ADDENDUM NO. 2

REYNOLDSBURG CITY SCHOOLS
L.F.O. ATHLETIC & ECO LAB PROJECTS

Date: **March 30, 2011**

Addendum No. 2 to the Drawings and Project Manual, dated **March 17, 2011**, for **L.F.O. ATHLETIC & ECO LAB PROJECTS**, Reynoldsburg City Schools, 7244 East Main Street, Reynoldsburg, Ohio 43068; as prepared by Moody Nolan, Inc., 300 Spruce St. Suite 300, Columbus, OH 43215.

SKETCH NUMBER
E-SK01

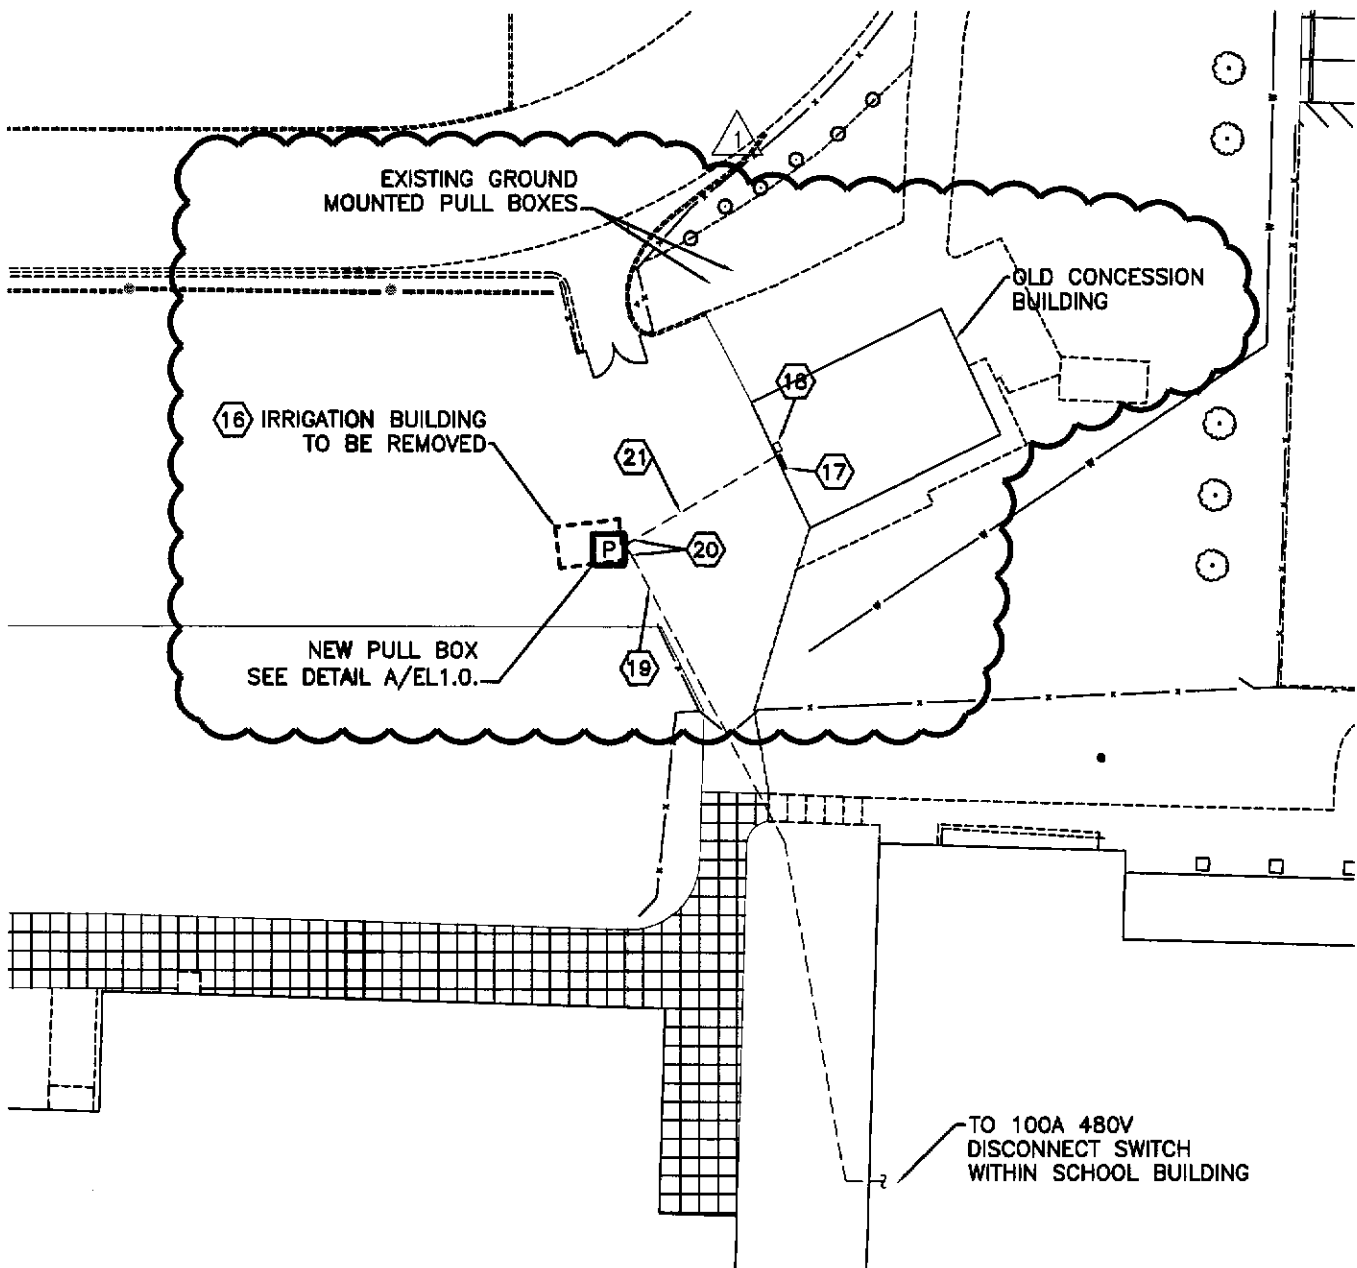
- a. Per sketch E-SK01 demolition of existing Irrigation Building at Livingston HS site is included in this project. The EC shall remove the building electrical service while maintaining the electrical service to the existing Old Concession building.
- b. Per sketch E-SK02 demolition of existing Visitors Concessions Building at Livingston HS site is included in this project. The EC shall remove the building electrical service.

- 15 EXISTING BUILDING TO BE REMOVED BY OTHERS, EC TO DISCONNECT ELECTRIC SERVICE, REMOVE ALL WIRING BACK TO LAST ACTIVE DEVICE.
- 16 EXISTING BUILDING TO BE REMOVED BY OTHERS. EC TO REMOVE ALL EXISTING DISCONNECT SWITCHES WITHIN FEEDING IRRIGATION EQUIPMENT AND THE CONCESSION BUILDING. REMOVE EXISTING 50KVA TRANSFORMER AND RELOCATED IN OLD CONCESSION BUILDING, SEE NOTE 18.

SOFTBALL BLDG. SECOND FLOOR LIGHTING

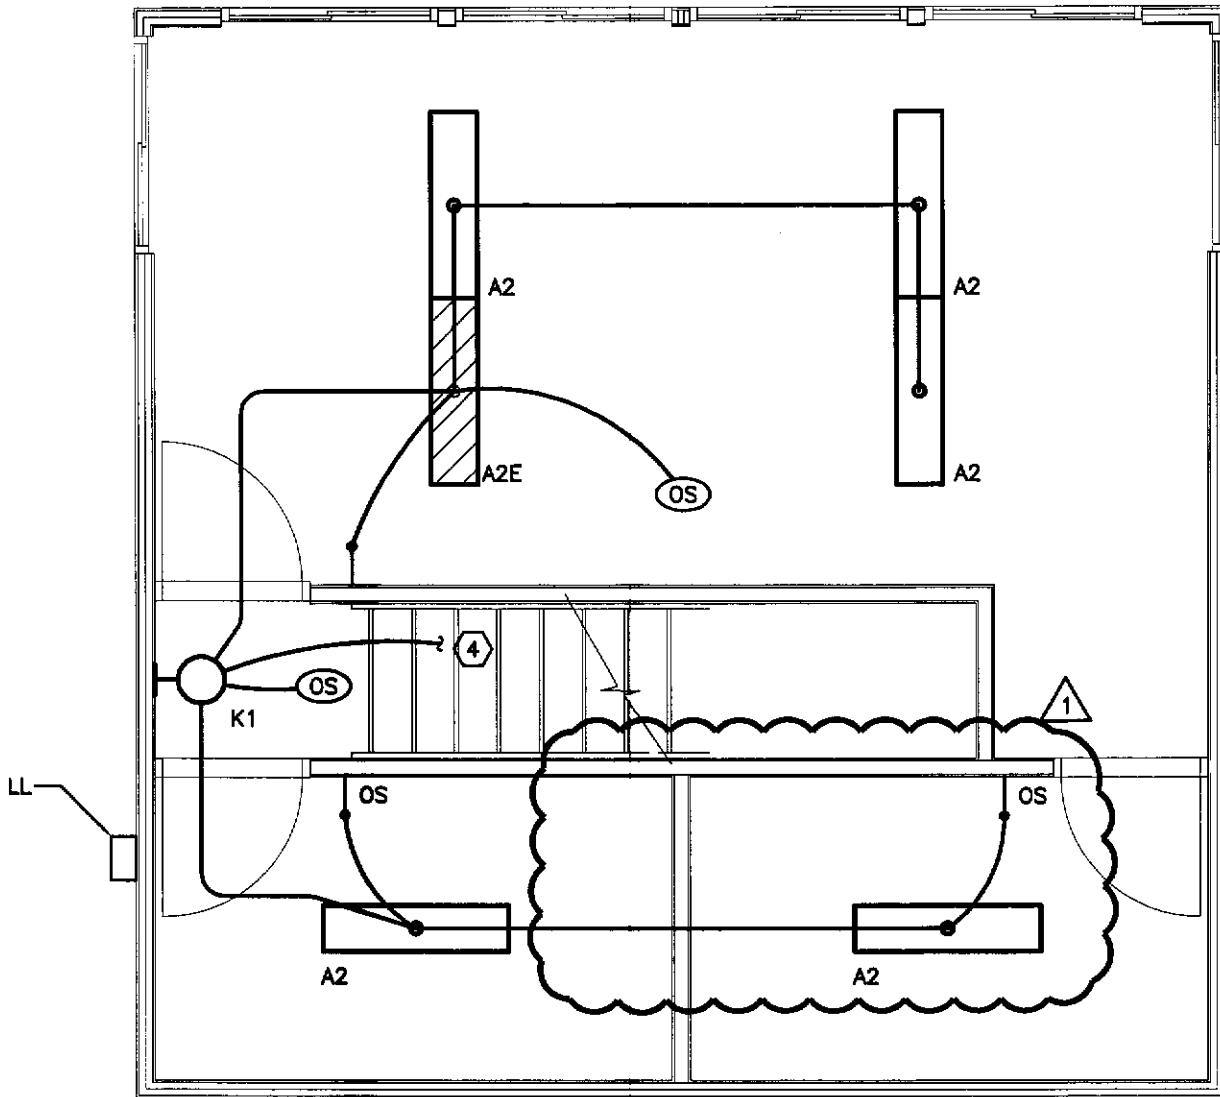
- Item 2-24 Sheet Ed1.11 Vol. 2:
- a. The lighting layout has been modified due to the architectural change, see sketch E-SK04.
 - b. The power layout has been modified due to the architectural change, see sketch E-SK05.

ISSUED WITH ADDENDUM 2	SHEET REVISED Es1.0
SKETCH NUMBER E-SK07	
PROJ # 08:77.1	DRAWN BY KLM
DATE 3/30/11

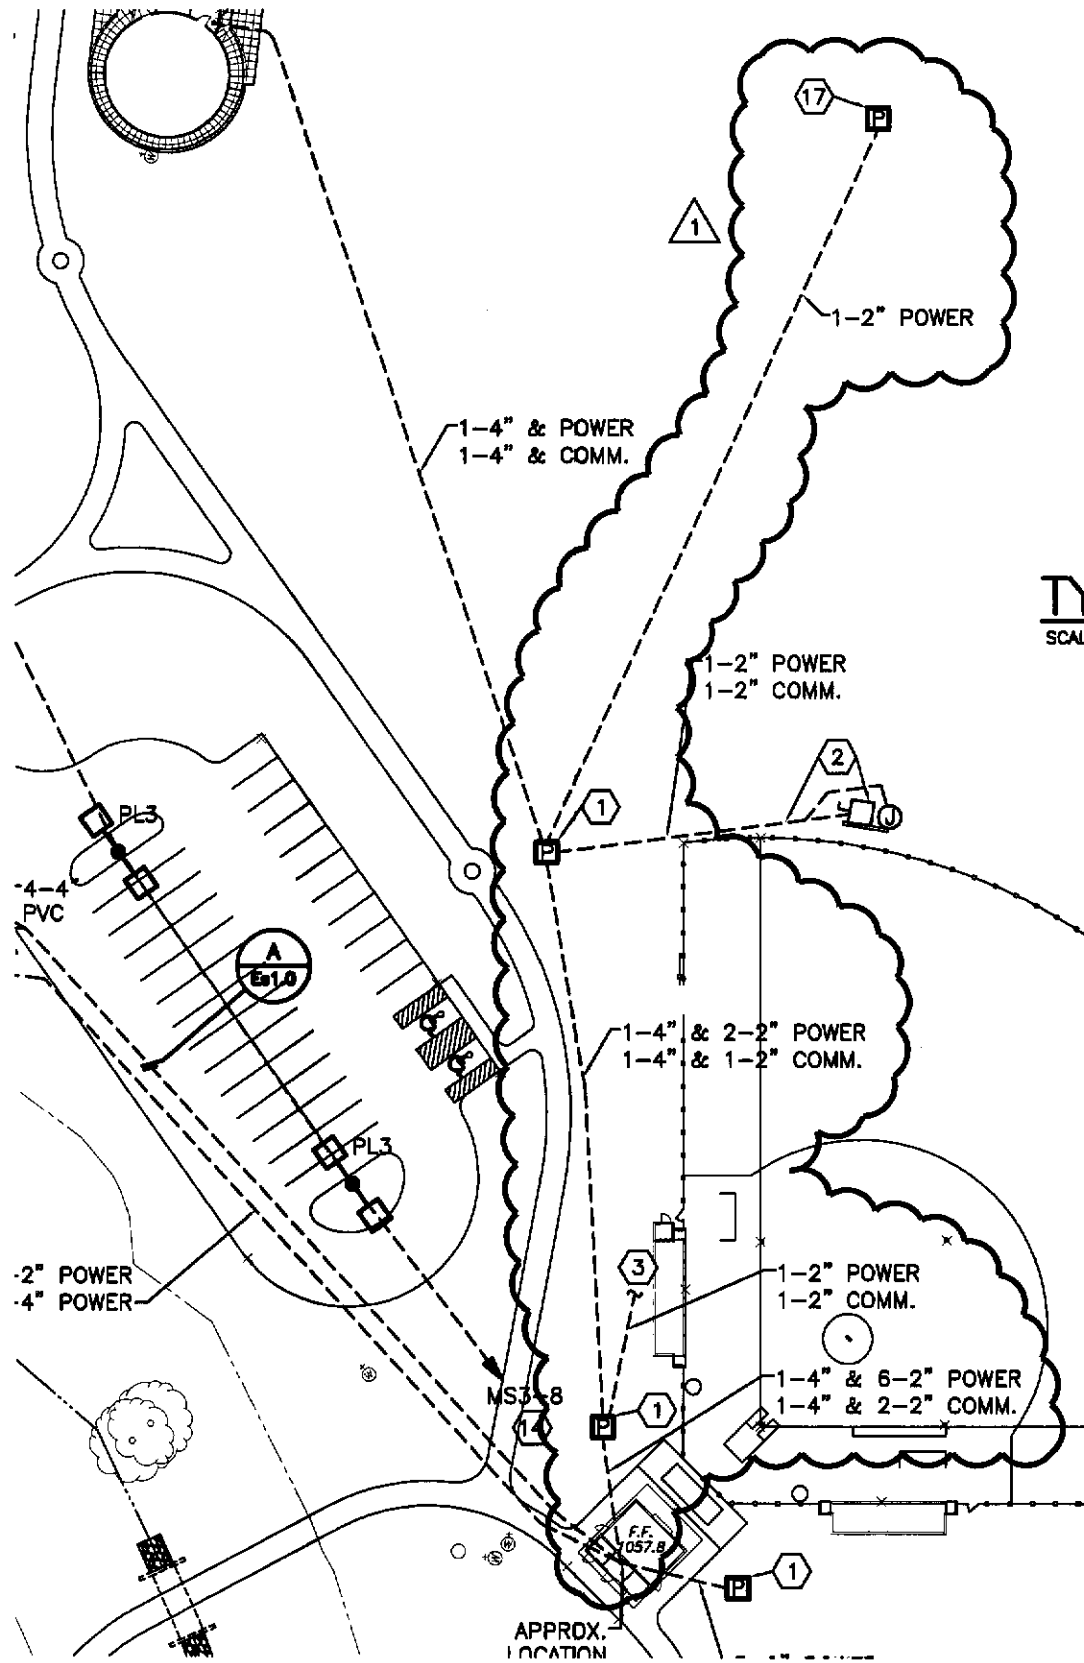
- Item 2-26 Sheet Es1.0 Vol. 2:
- a. Add pull box, conduit and conductors shown on sketch E-SK07 to supply power to the well, and pond pumps.
 - b. Add plan note #17 as shown on sketch E-SK08.

17 NEW PULL BOX, SEE DETAIL D/Es1.0. EXTEND TWO THREE PHASE CIRCUITS TO BOX TO SERVE WELL PUMP AND POND PUMP. EACH SIZED AT 5HP 480V - 3PH. CIRCUITS SHALL TERMINATE AT ASSOCIATED PUMP CONTROL PANEL, COORDINATE FINAL LOCATION OF PULL BOX AND CONTROL PANELS WITH ARCHITECT/CIVIL CIRCUIT TO MS3-20 & 21; 3-#10 & 1-#10 GRD IN 2" C.

FIRE SUPPRESSION PLAN

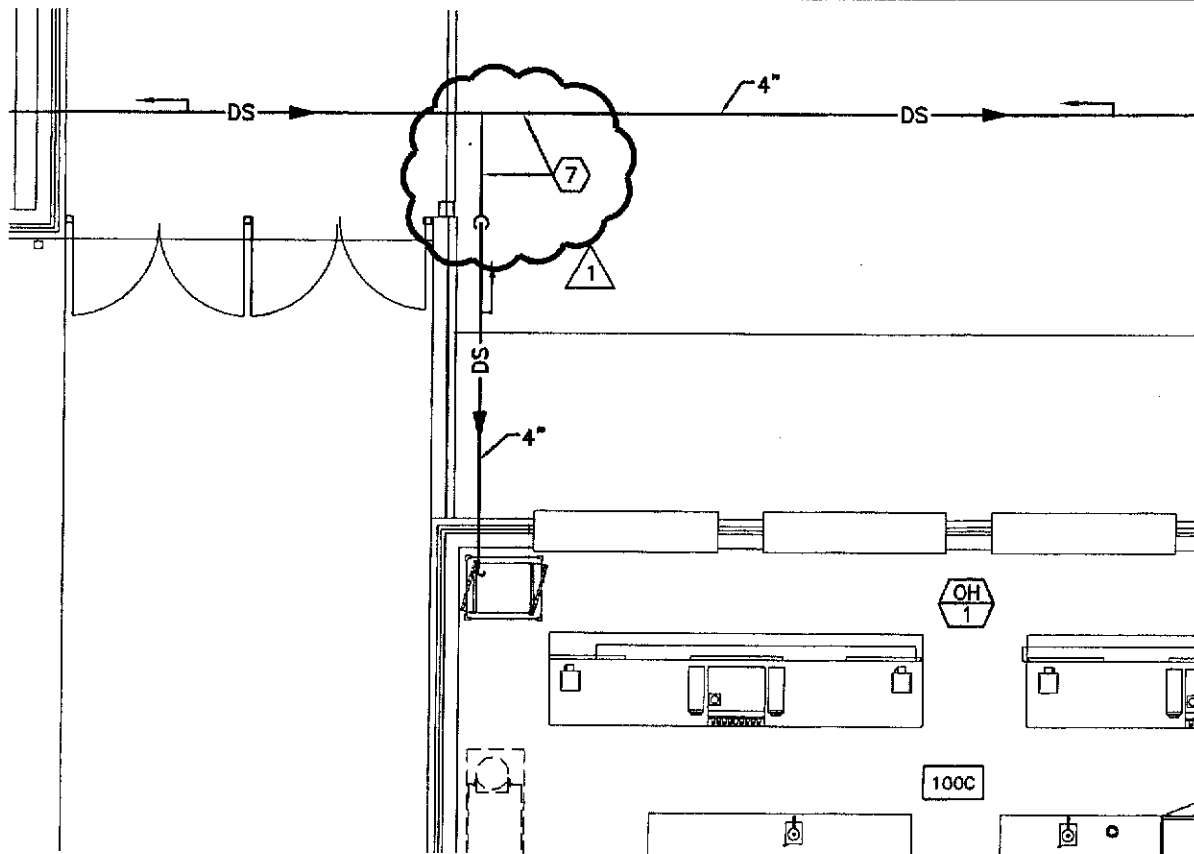
- a. Add plan note 7 to read, "Sprinkler piping shown is a "general" routing for information only. FSC shall determine final routing as required by the hydraulic calculations and as coordinated with the Architect. All piping shall be installed per NFPA 13 requirements" per attached sketch F-SK01.

- 1 PIPING LOCATED BELOW FINISHED FLOOR IN GRADE.
- 2 CONNECT TO PIPING PROVIDED BY SUC.
- 3 DOMESTIC WATER SERVICE BY PC.
- 4 SPRINKLER PIPING TO DROP CONCEALED IN PIPING CHASE.
- 5 1" INSPECTOR'S TEST PIPING FROM MOST REMOTE ZONE BRANCH PIPE.
- 6 SPRINKLER PIPING SHALL PENETRATE BUILDING WALL 24" AFG AND ELBOW DOWN. PROVIDE CONCRETE SPLASH BLOCK UNDER OUTLET AND SMOOTH BORE OUTLET EQUAL TO SMALLEST SPRINKLER OUTLET ON INSPECTOR'S TEST PIPING.
- 7 SPRINKLER PIPING SHOWN IS A "GENERAL" ROUTING FOR INFORMATION ONLY. FSC SHALL DETERMINE FINAL ROUTING AS DETERMINED BY HYDRAULIC CALCULATIONS AND AS COORDINATED WITH ARCHITECT. ALL PIPING SHALL BE INSTALLED PER NFPA 13 REQUIREMENTS.

SOFTBALL BLDG. SECOND FLOOR HVAC

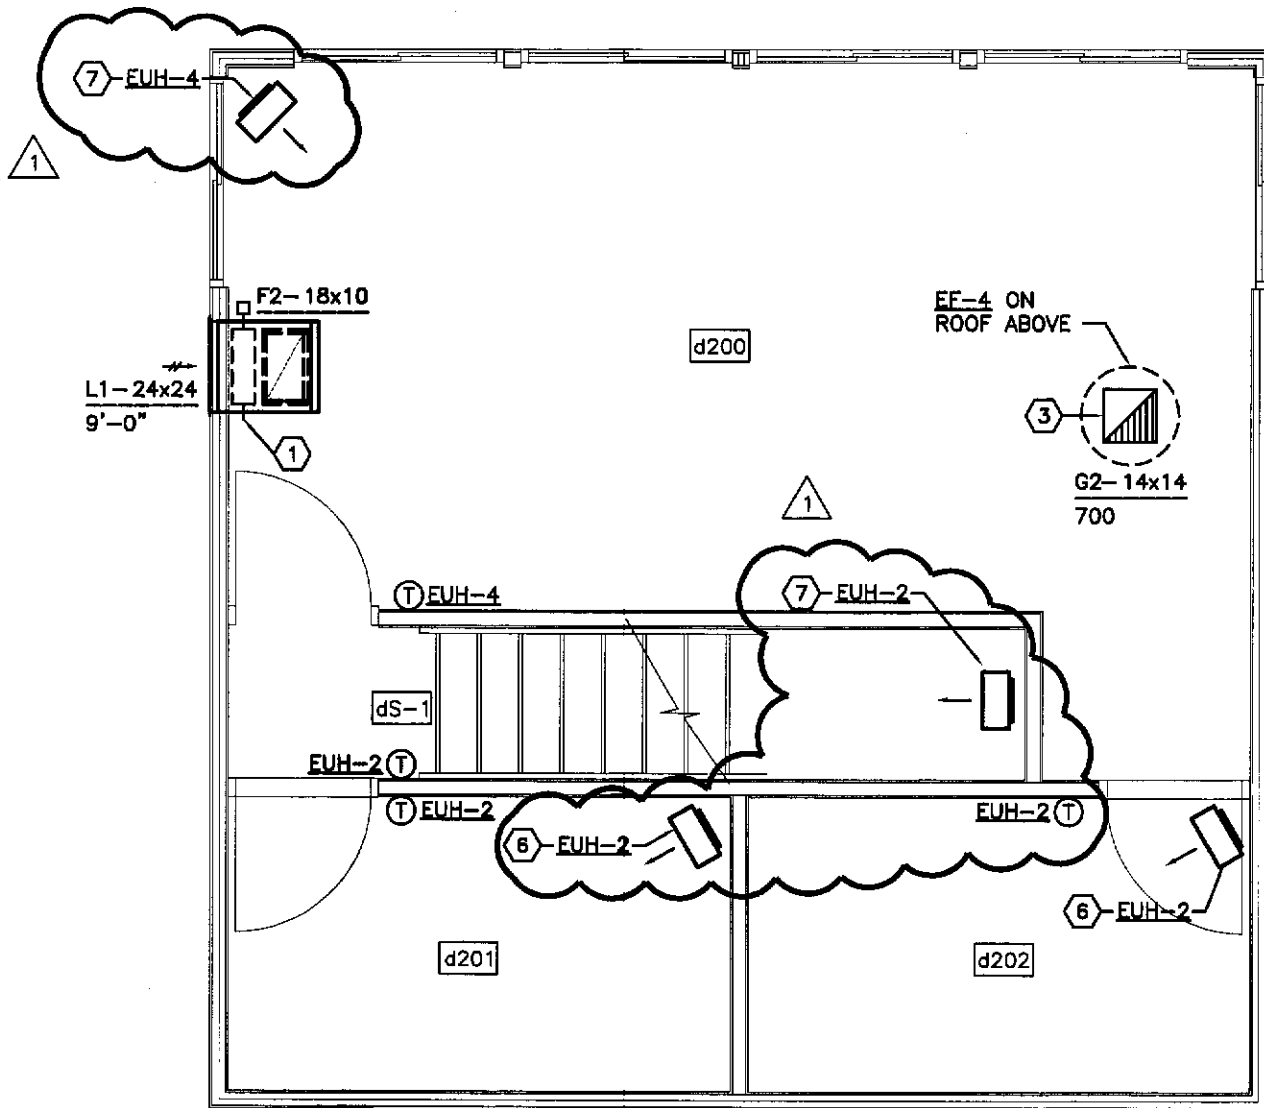
- Item 2-27 Sheet Hd1.1 Vol. 2:
- a. Revise heater type in Press Box Room d200 to EUH-4 per attached sketch H-SK01.
 - b. Move EUH-2 in stairwell to vertical wall parallel to doorway per attached sketch H-SK01.

- c. Provide a wall mounted heater, EUH-2, and associated thermostat in new Storage Room d201 per attached sketch H-SK01.

PARTIAL FOUNDATION PLAN

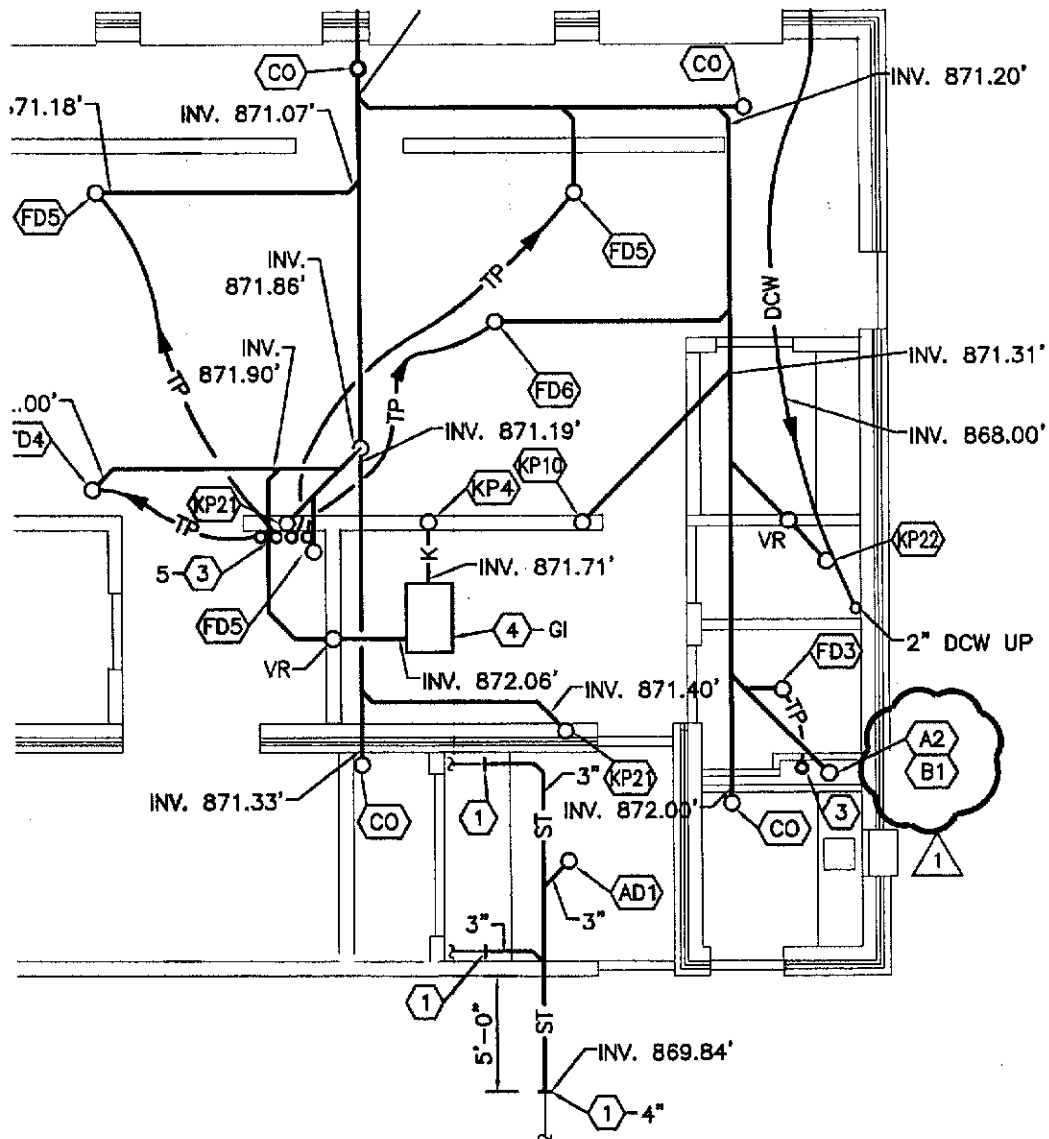
- a. Revise water closet type to "A2" on foundation plan per attached sketch P-SK02.

ENLARGED PLAN

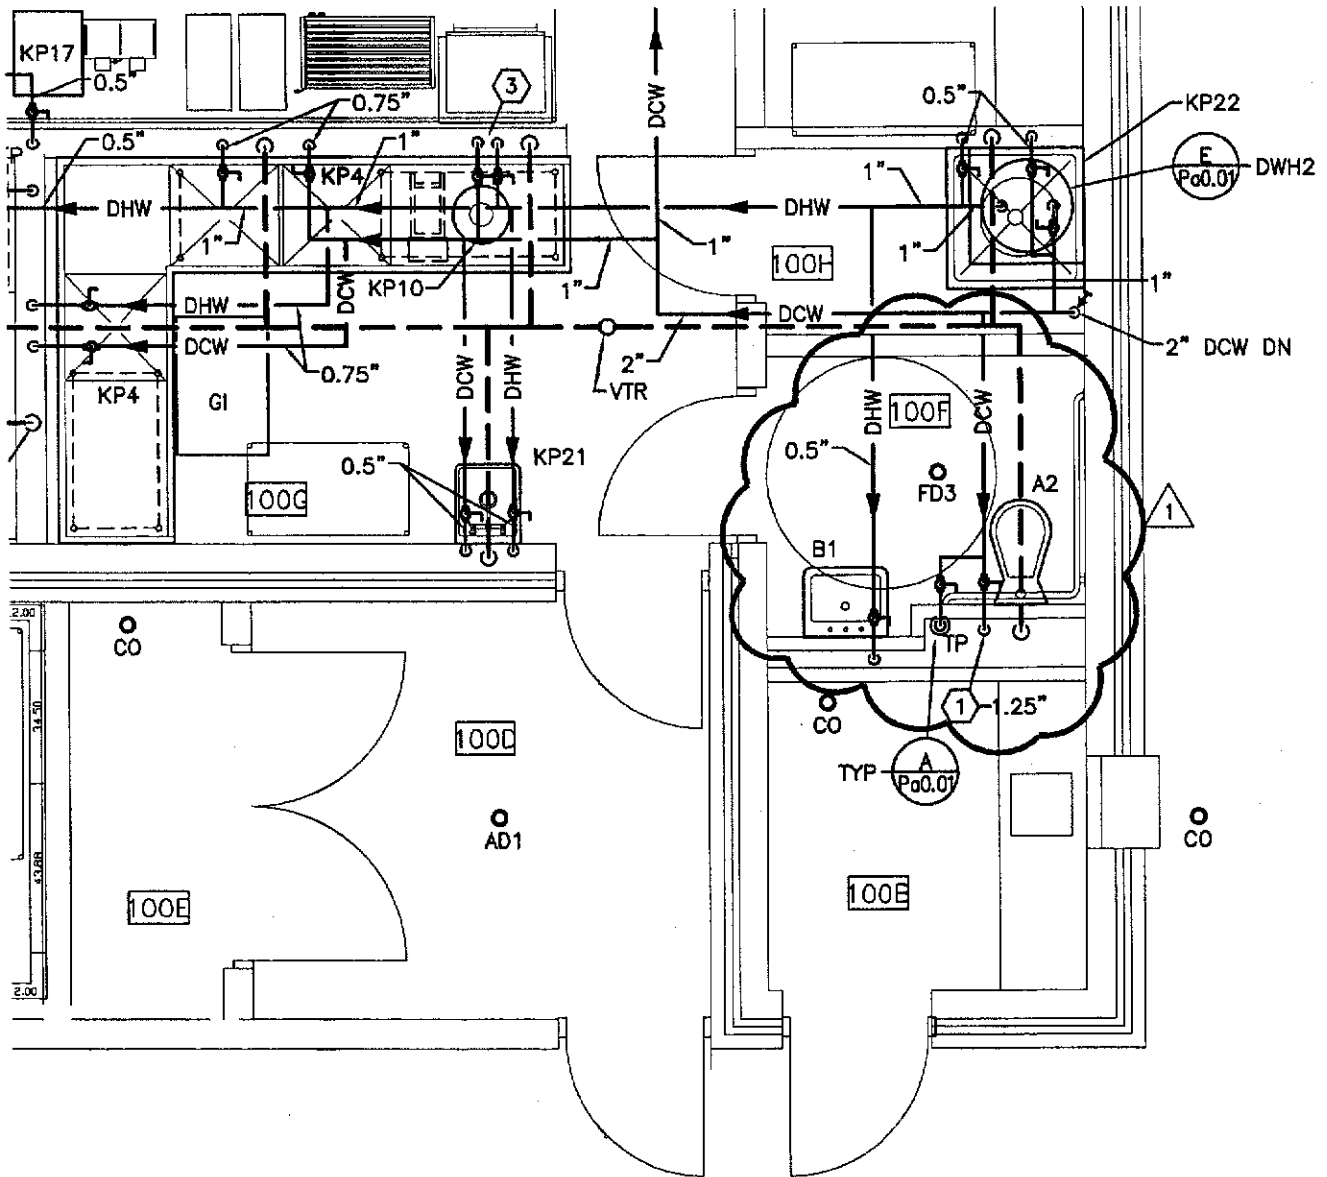
- Item 2-18 Sheet Pa2.11 Vol. 1:
- a. Revise water closet type to "A2" in Room 100F on enlarged plan per attached sketch P-SK03.
- Item 2-19 Sheet Pa4.11 Vol. 1:
